- 8. Millers Crossing Subdivision Phase 2; KPB File 2025-071
McLane Consulting Group / Hall Building, LLC
Location: Miller Loop Road & Morel Avenue
Nikiski Area / Nikiski APC**

**ITEM #8 - PRELIMINARY PLAT
MILLERS CROSSING SUBDIVISION PHASE 2**

KPB File No.	2025-071
Plat Committee Meeting:	May 27, 2025
Applicant / Owner:	Hall Building LLC of Nikiski, Alaska
Surveyor:	Andrew Hamilton; McLane Consulting Inc.
General Location:	Near Milepost Two Miller Loop Road, Nikiski Area

STAFF REPORT

**MILLERS CROSSING SUBDIVISION
PHASE 2
A SUBDIVISION OF
TRACT A MILLERS CROSSING SUBDIVISION PHASE 1 (KN2014-57)**

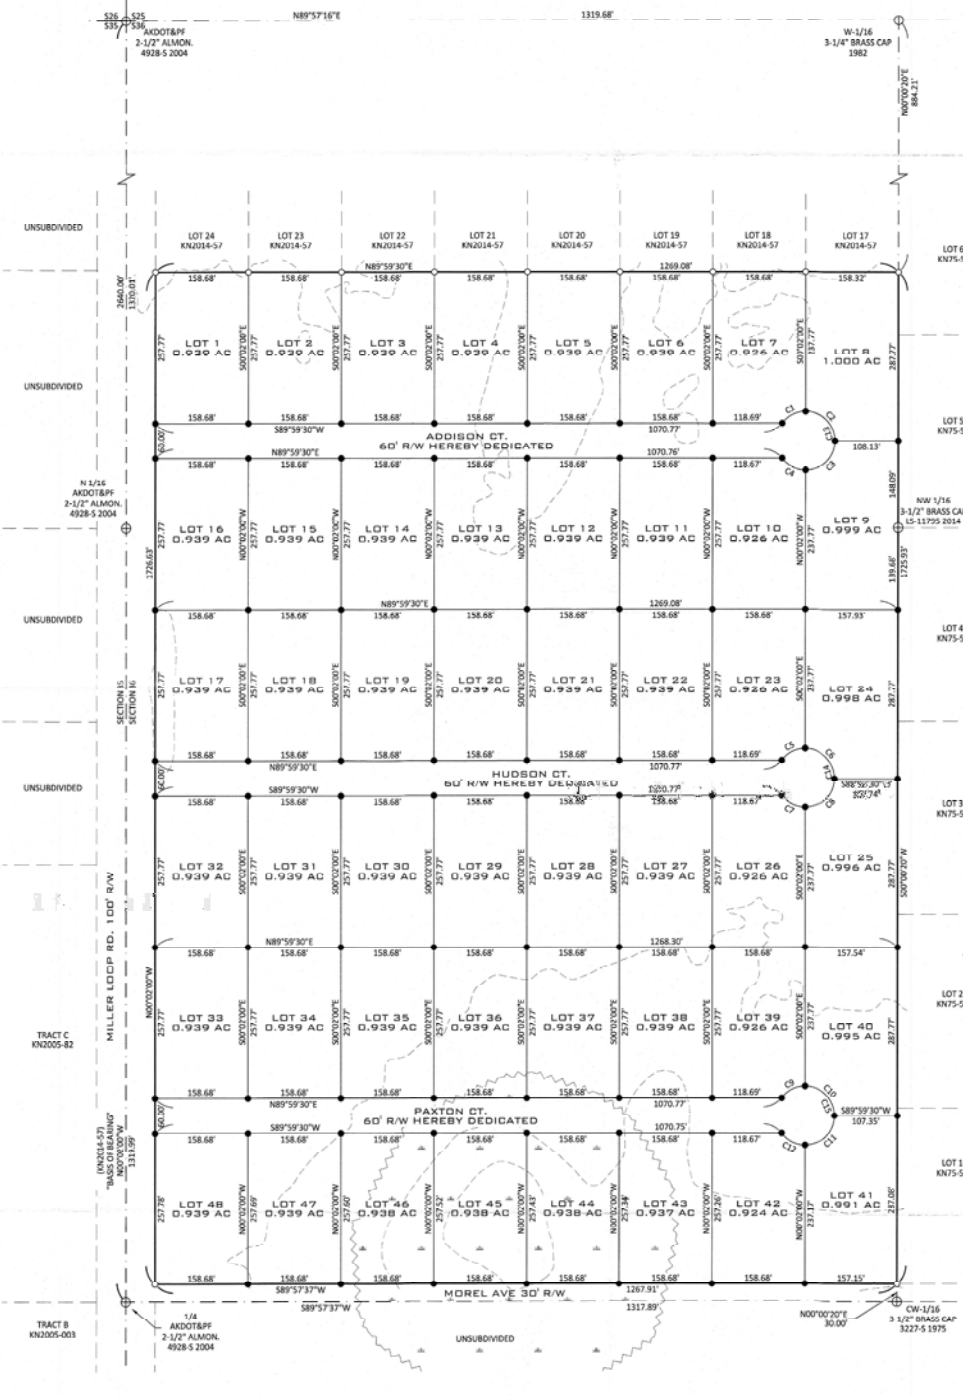
There is a section line easement located within Miller Loop Road. **Staff suggests** the surveyor verify the width of the section line easement and add labels for the easements to the preliminary plat.

The Surveyor has included contours at intervals of 5-feet on the preliminary plat. No areas appear to exceed the allowable slope grade per code. **Staff recommends** that the contours can be removed for the final submittal.

According to KWF Wetlands Assessment, wetlands indicated as a depression is located to the south. The surveyor has included the wetlands area on the preliminary plat. **Staff recommends** the surveyor place a note on the final plat indicating any person developing the property is responsible for obtaining all required local, state, and federal permits, including a U.S. Army Corps of Engineers wetland determination if applicable.

The KPB River Center Reviewer identified that proposed plat to be located within a flood hazard area, Flood Zone D. **Staff recommends** the surveyor add the flood hazard notice including the Flood Hazard Zone and Map Panel.

The parent plat, KN 2014-57, granted a 15-foot utility easement and the entire setback within 5-feet of side lot lines adjacent to rights-of-way. **Staff recommends** the surveyor correct the plat note 3 and the detail to the 15' distance from the parent plat.

- Modify Plat Approval Date to May 27, 2025
- Modify KPB File Number to 2025-071

- Verify and show the section line easements to the west
- Morel Avenue to the southeast may need to be modified to a 60 R/W due to dedication from Salamatof Lake Subdivision (KPB 2025-041). Verify prior to printing to mylar if Salamatof Lake Subdivision finalizes first, to include the correct ROW width to be shown on the mylar.

- Move labels for the ranges and townships to the correct lines
- Section 32 should be section 6

15' utility easement dedicated on parent plat correct plat note 3 and detail

- Located to the Southeast is Salamatof Lake Subdivision (KPB 2025-041). Verify prior to printing to mylar if Salamatof Lake Subdivision finalizes first, to include the correct ROW width of Morel Avenue, Lot Lines, Block Numbers and Lot numbers on the mylar.
